Response to Comments

City of Kendrick Wastewater Treatment Plant

NPDES Permit Number: ID0024554

June 27, 2018

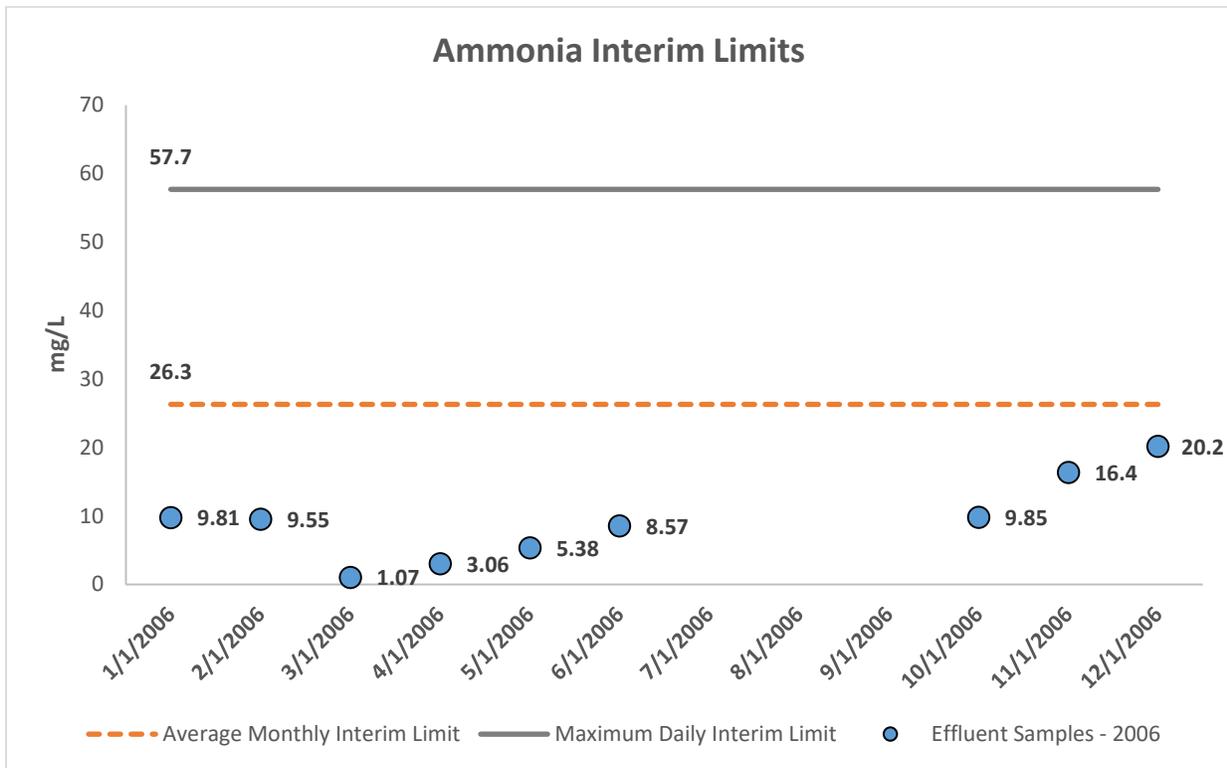
Comment 9. Ammonia (As N – Interim) (Kendrick)

The upgraded treatment plant may at times meet the listed limitations. However, the treatment plant was not specifically designed to reduce ammonia effluent concentrations. We have limited operational strategies to meet the proposed limits should weather patterns be unfavorable for an

extended period of time. We would request that the interim limits be removed from the permit but are agreeable to continue monitoring and collecting effluent ammonia data.

As part of its current permit, Kendrick was required to monitor effluent Ammonia concentrations during 2006. Kendrick reported nine values within the range of 1.07 – 20.2 mg/L. As stated in Appendix E of the Fact Sheet, EPA used these measured concentrations to develop performance based effluent limits consistent with EPA’s *Technical Support Document for Water Quality-based Toxics Control*. Performance based calculations assume pollutant discharges are lognormally distributed to determine monthly average and daily maximum permit limits. The interim limits included in the permit will ensure that the facility is making the necessary changes to improve treatment operations and move towards compliance with the final effluent limits as soon as possible. As can be seen below, this methodology accounts for variability in effluent discharge and both the maximum daily limit and average monthly limit are greater than any observed values at the wastewater treatment plant. The EPA will not remove interim Ammonia limits from the permit.
